WH17 - Replacing Front Right Power Windows Mechanism (Workshop Campaign)

Model Line: **Panamera (971)**

Subject: **Front right power windows mechanism**

Front right power windows mechanism

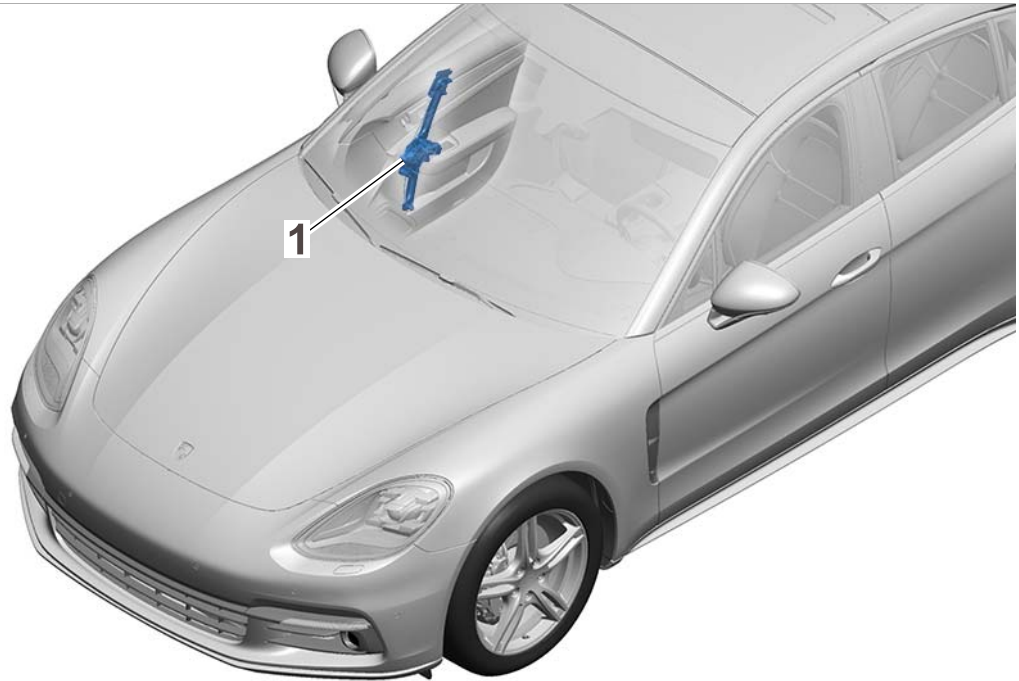
Information: **An unfavorably positioned drain bore in the front right power windows mechanism can prevent moisture that penetrates via the window channel from being drained completely.**

If this moisture freezes at low outside temperatures, the mechanism can be damaged when the front right power window is actuated. As a result, the front right side window will no longer close.

1 – Front right power windows mechanism (**replace**)

Remedial Action: Replace front right power windows mechanism.
